TECHNICAL BULLETIN INDEX
Sorted by Bulletin Number
04/03/86

BULLETIN NO: II:1

PRODUCT: 26-4001/2 Model II

SUBASSEMBLY: AXX-0505 FDC Board Early Design (All Revisions)
AX-9033 FDC Board Late Design (All Revisions)

Figure 1

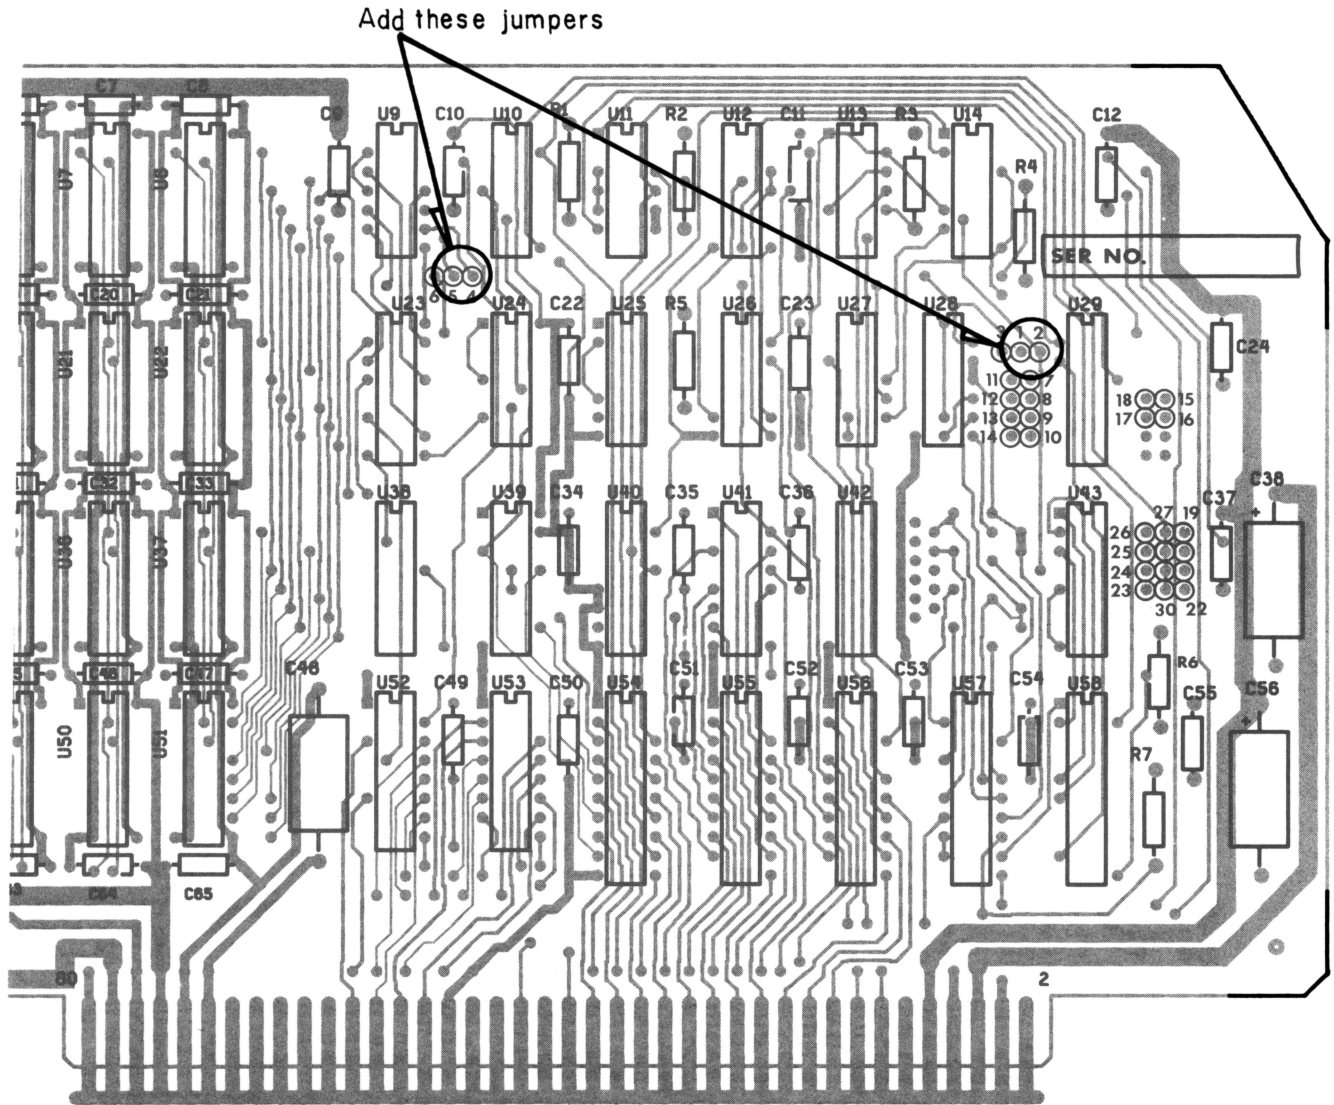
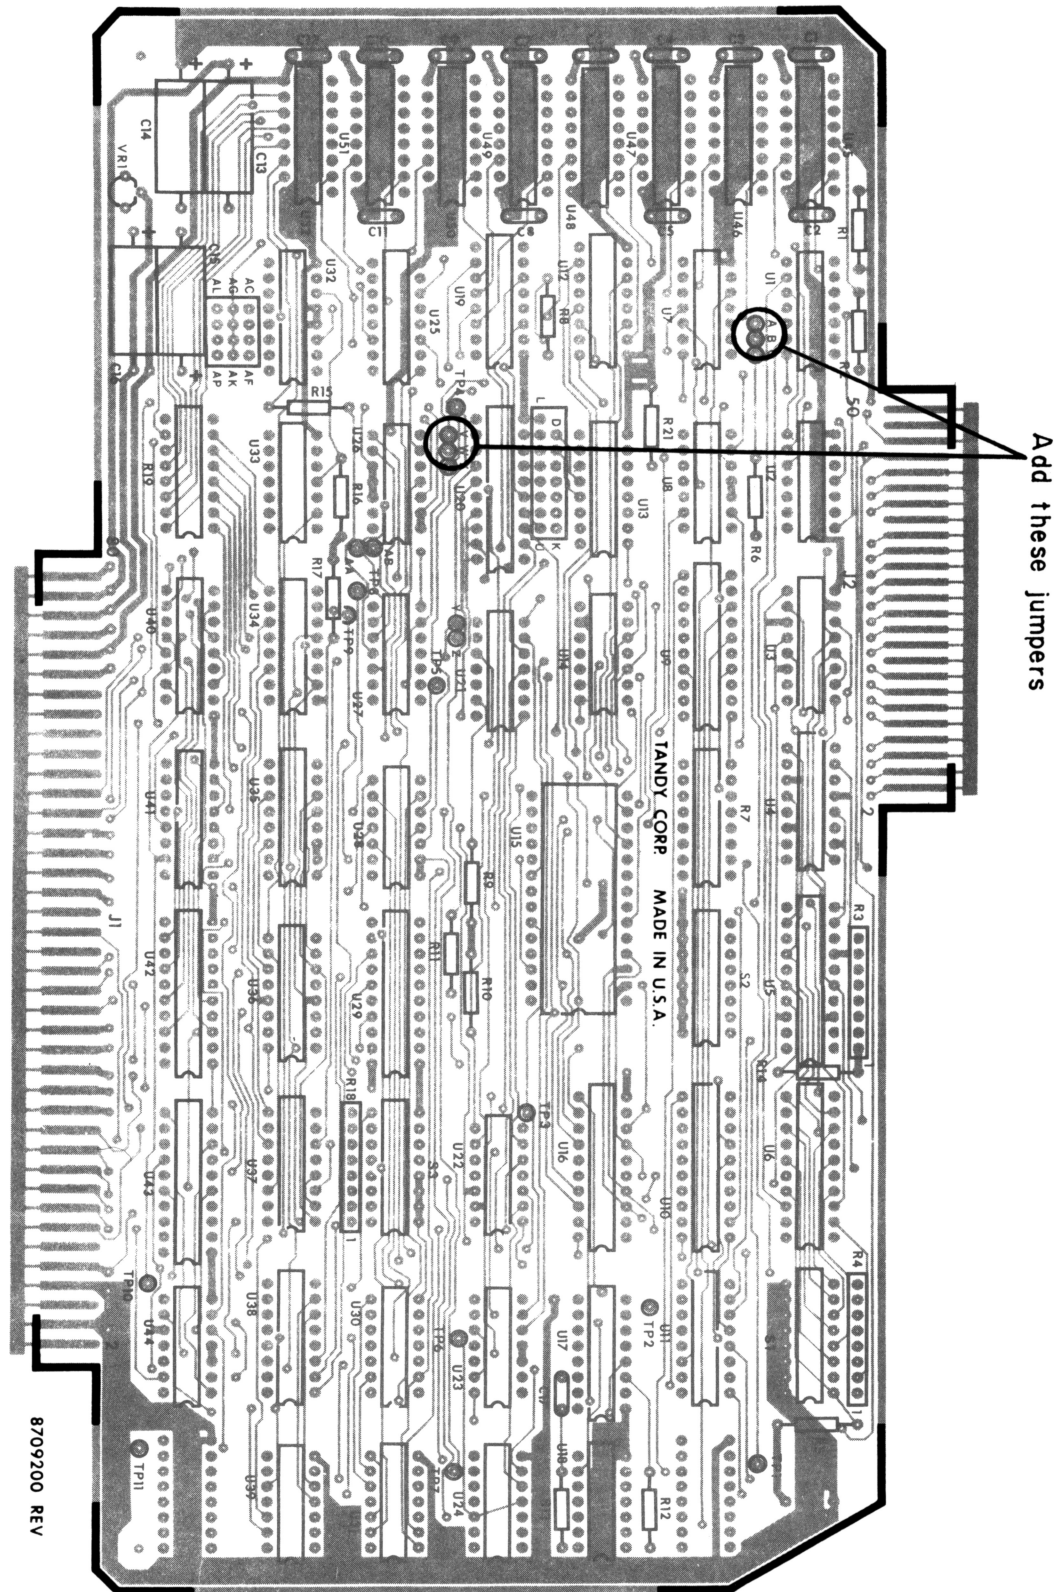
DISCUSSION: Pullups are needed on memory boards for inputs to gates. Intermittent problems can occur without these pullups installed. Some of the Model II memory boards may be missing staking pins for push on connectors and appropriate markings. In this case, use wirewrap to jumper the pads and refer to Figure 1 for pad locations.

PROCEDURE: Check boards for proper jumpering and install jumpers if they are missing. For physical locations of jumpering positions refer to Figure 1 for the memory board and Figure 2 for the Interface board.

Hard Disk Interface:
Jumper A-B and W-V

Model II Memory boards:
Jumper 1-2 and 5-6

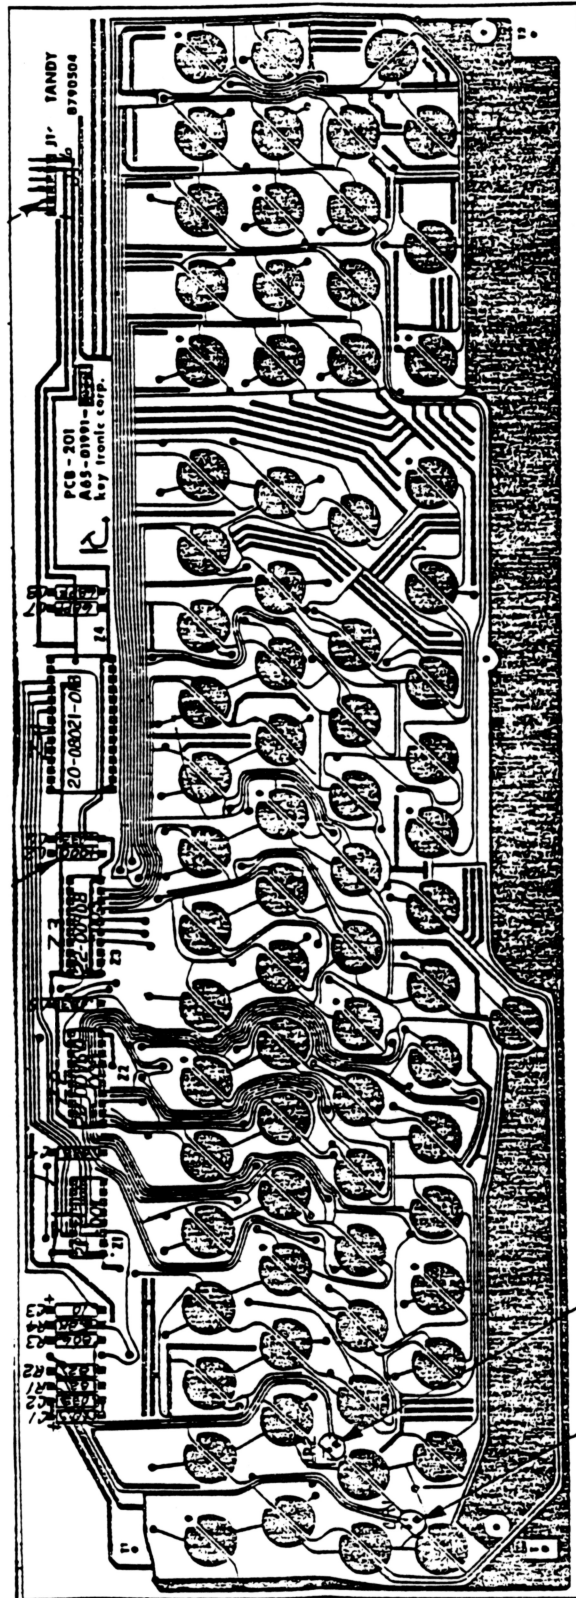
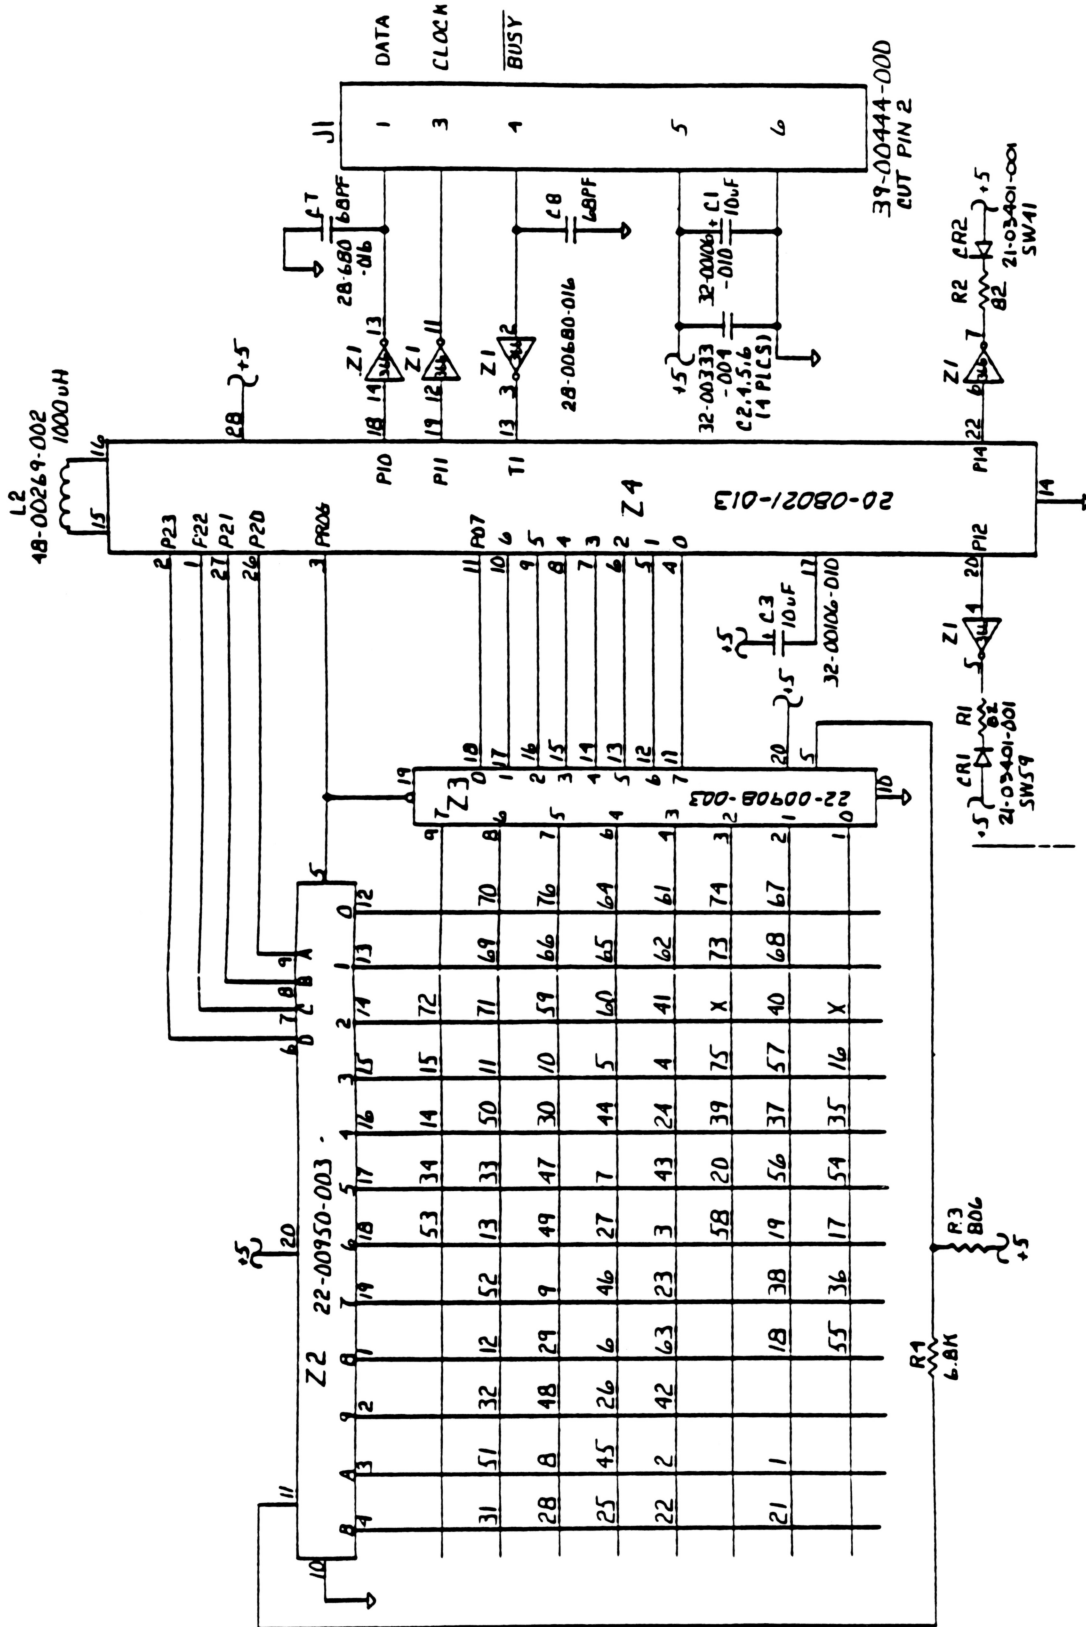
PURPOSE: Correct, and clarify the schematics on the model II/16 Key Tronic keyboards.

DISCUSSION: The Schematics for the Model II/16 keyboards in the Model II Technical Reference Manual are incorrect. Attached is the correct schematic and component location diagram.
